**PETITION OF LSE HERCULES LLC
FOR A DECLARATORY RULING
THAT NO CERTIFICATE OF ENVIRONMENTAL
COMPATIBILITY AND PUBLIC NEED IS
REQUIRED FOR THE CONSTRUCTION,
OPERATION, AND MAINTENANCE OF
A 4 MW AC SOLAR PHOTOVOLTAIC
FACILITY IN ENFIELD, CONNECTICUT**

PETITION NO. 1557

LSE HERCULES LLC'S INTERROGATORY RESPONSES
COUNCIL INTERROGATORIES SET ONE

SHEET NUMBER:
EX-1

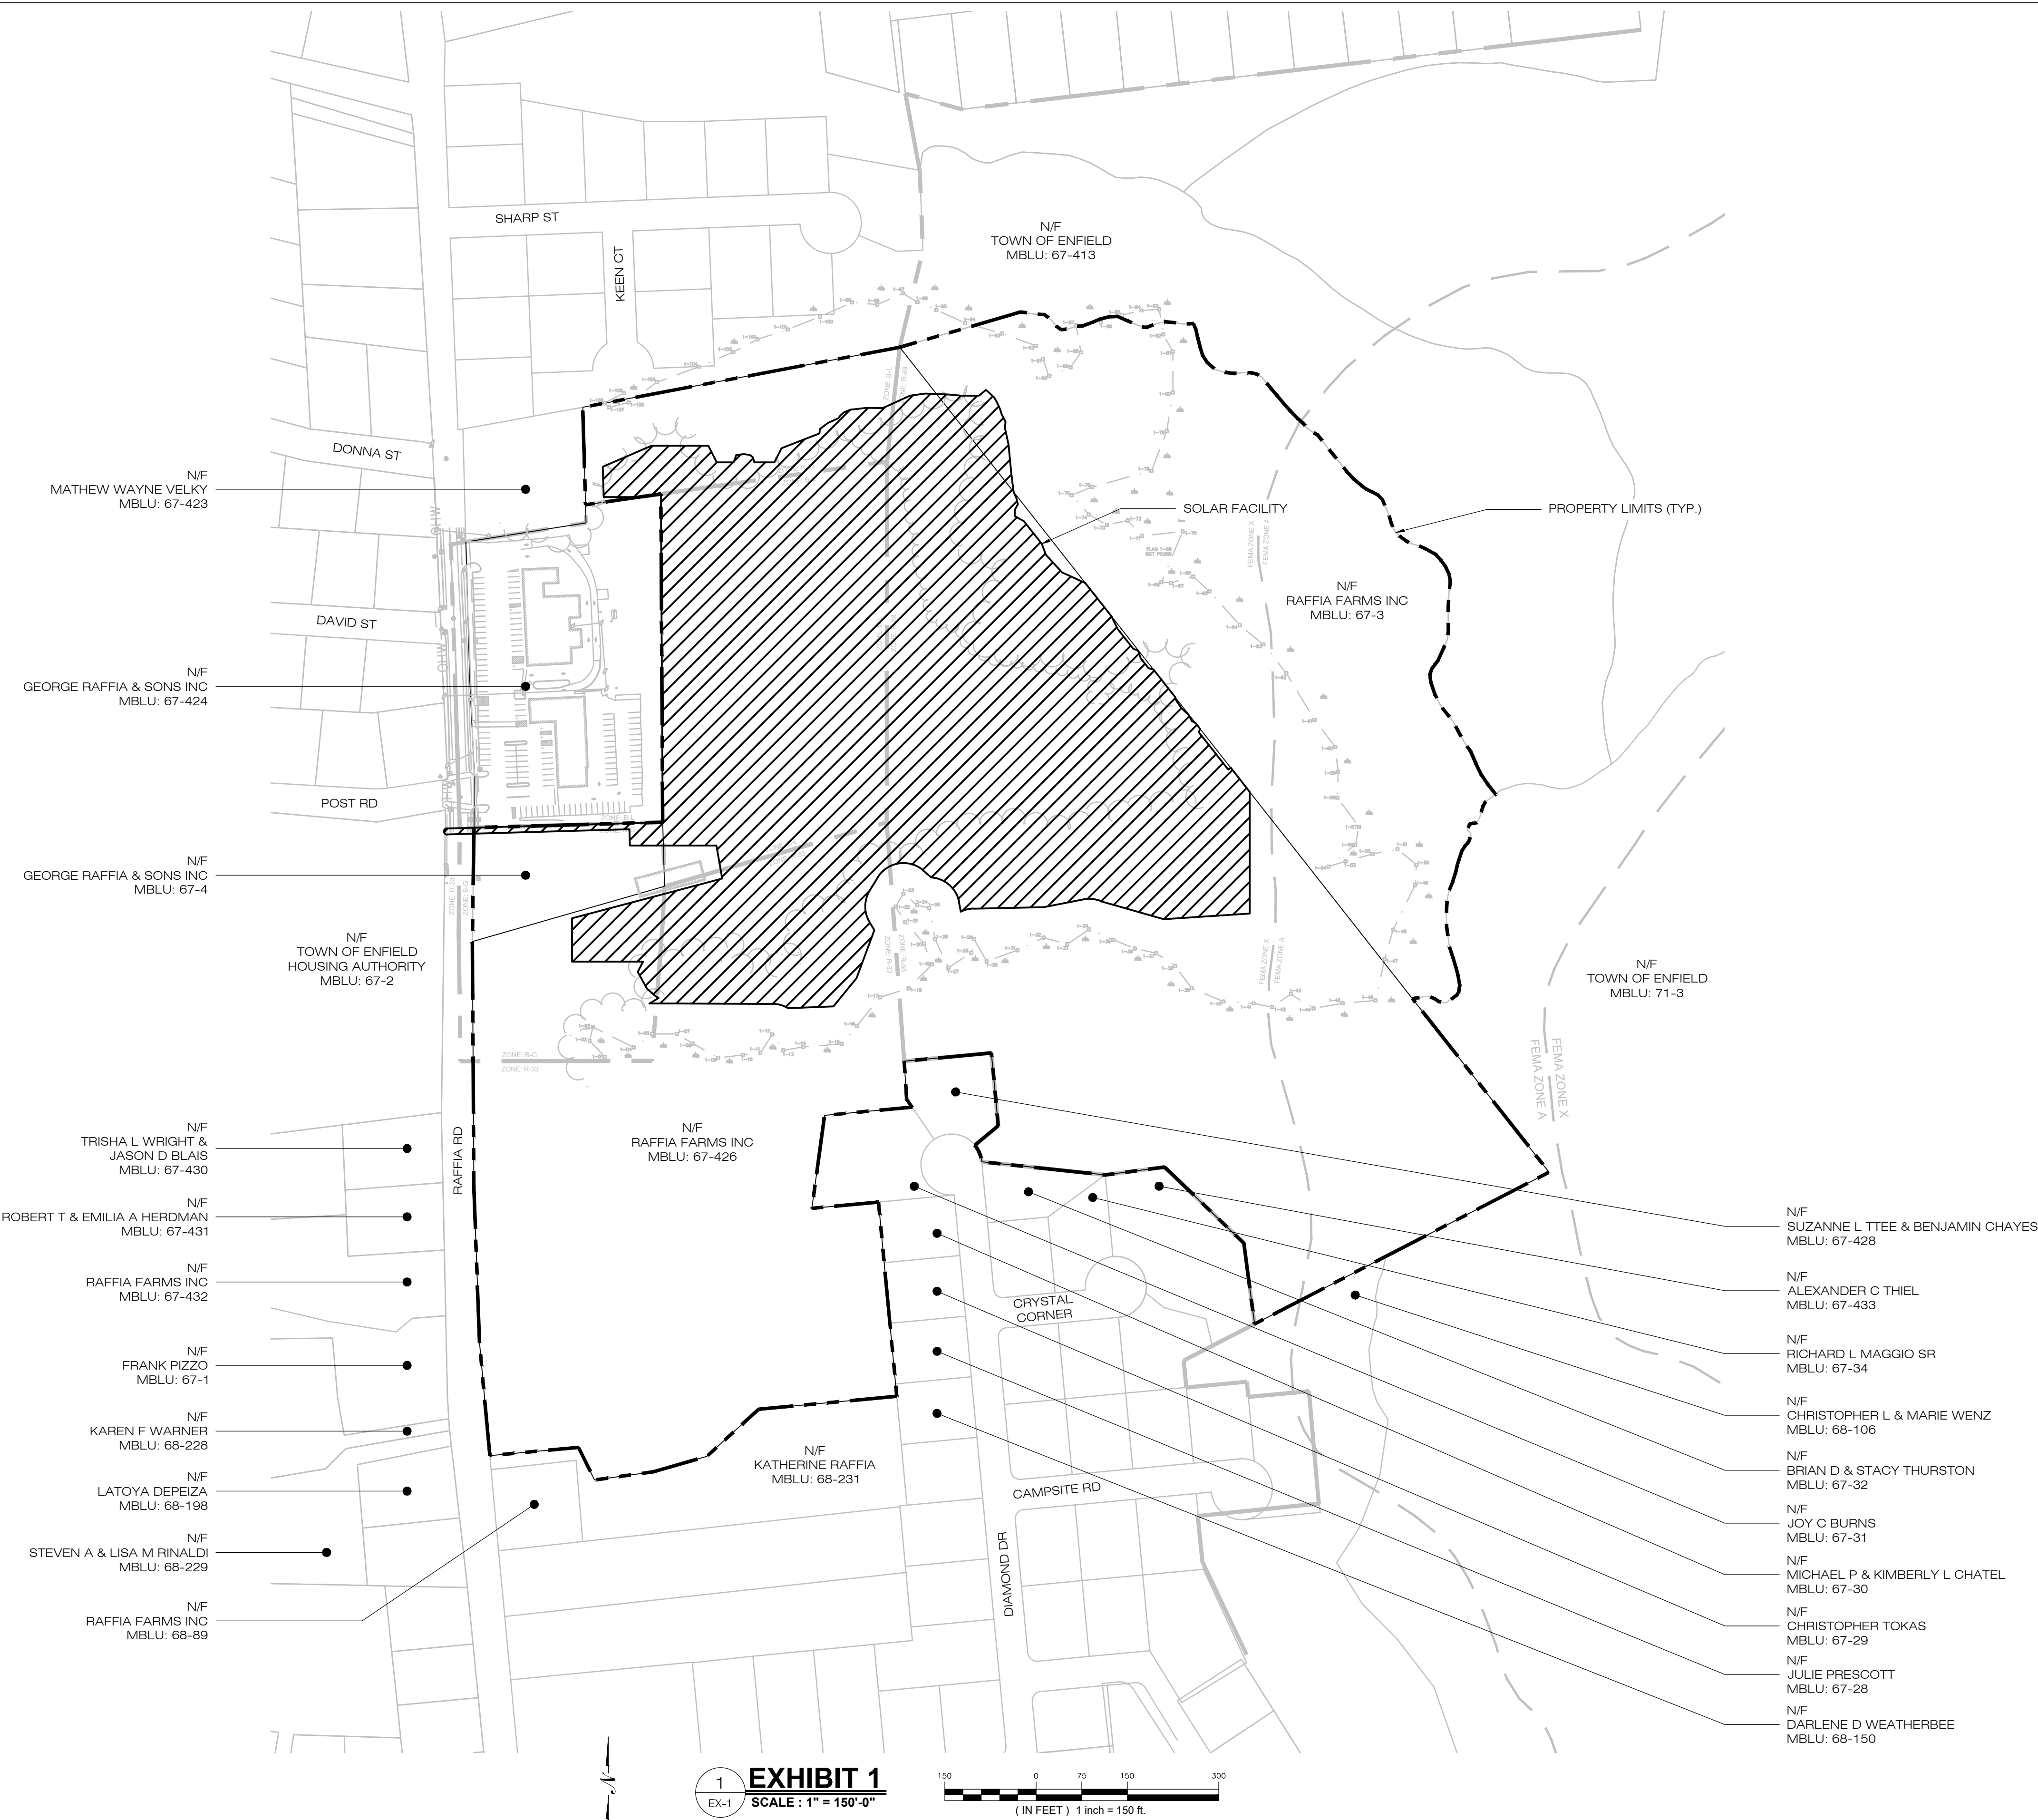
5. *Submit a map clearly depicting the boundaries of the solar facility site and the boundaries of the host parcel(s). Under Regulations of Connecticut State Agencies §16-50j-2a(29), "Site" means a contiguous parcel of property with specified boundaries, including, but not limited to, the leased area, right-of-way, access and easements on which a facility and associated equipment is located, shall be located or is proposed to be located.*

RESPONSE: See Exhibit 1 attached hereto.

EXHIBIT 2
EDGE FOREST MAP

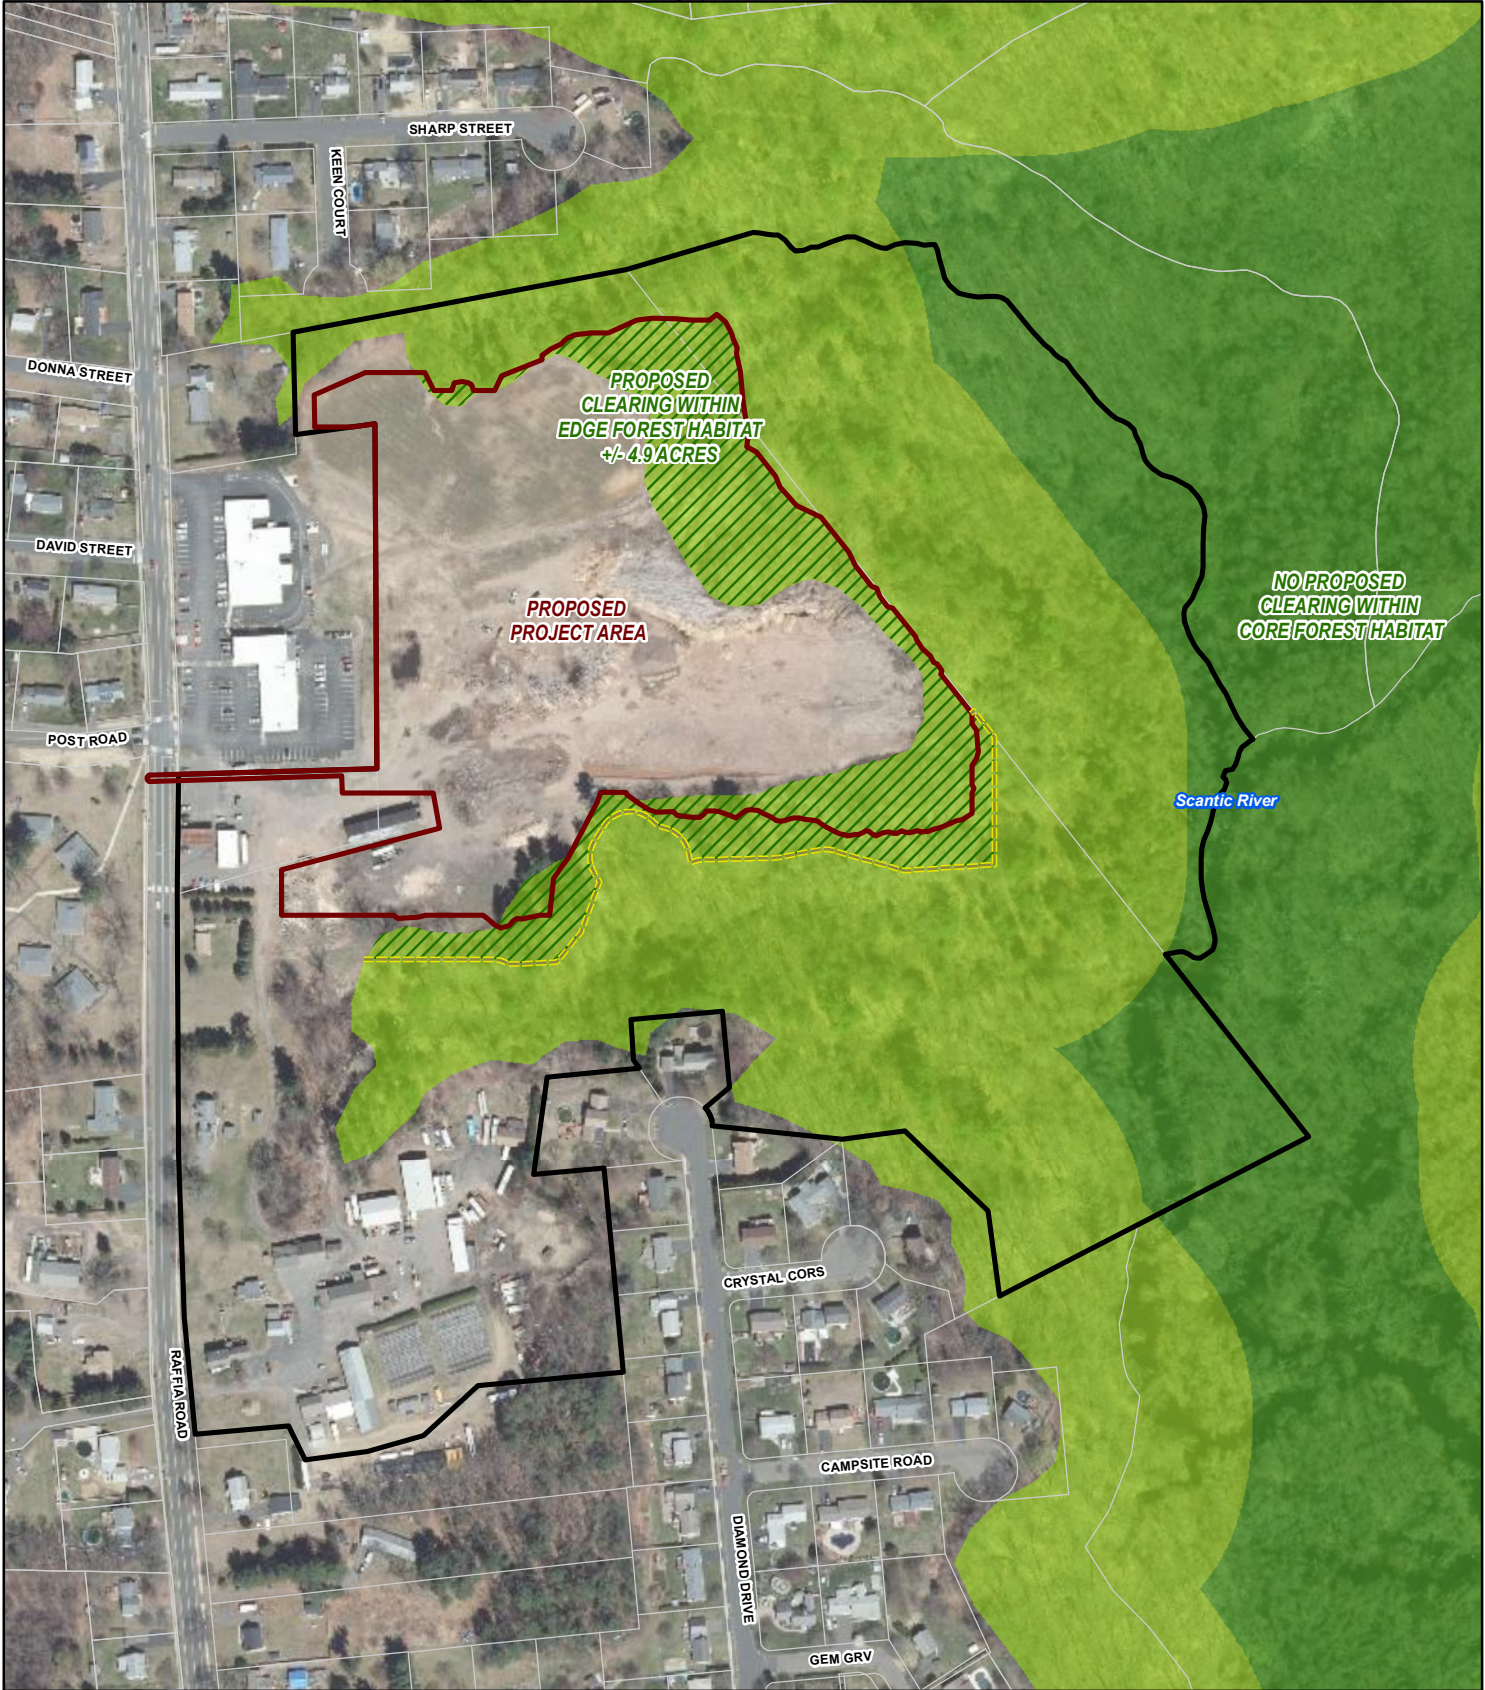
25. *Referencing page 19 of the Petition, Lodestar notes that there would be 1.21 acres of tree clearing. Referencing Attachment 7, Environmental Assessment, page 22, Lodestar notes that there would be approximately 3.50 acres of tree clearing. Please clarify. Of the total acreage of tree clearing, provide the acreage of tree clearing without grubbing and the acreage of tree clearing with grubbing.*

26. Under Connecticut General Statutes §16-50k, "Core forest" means unfragmented forest land that is three hundred feet or greater from the boundary between forest land and nonforest land, as determined by the Commissioner of Energy and Environmental Protection." Identify the number of acres of tree clearing within edge forest and the number of acres of tree clearing with core forest, if applicable. Provide an aerial photograph that depicts pre- and post-construction acreage of core and edge forest.

The 3.5 acres of impact referenced on page 22 of the Environmental Assessment (Exhibit 7 of the Petition) is a calculation of the Project's proposed impact to the "Edge Forest" habitat type within the Project Limit of Disturbance. An additional 1.35 acres of impact to the 'Edge Forest' habitat type is represented by the area of tree topping. See Exhibit 2 attached hereto.

RESPONSE: As provided in the petition filing, Petitioner consulted with DEEP and DEEP determined that the Project will have no impact on core forest. See Petition filing, Exhibit 7 at Appendix C, DEEP correspondence dated November 18, 2022. In addition, the Petitioner has reviewed all proposed clearing on-Site and confirmed that it will entirely occur within "edge forest" habitat. No tree clearing is proposed within core forest areas. Please see attached aerial view with core and 'edge forest' habitat pre- and post-construction depicted, as seen in Exhibit 2.
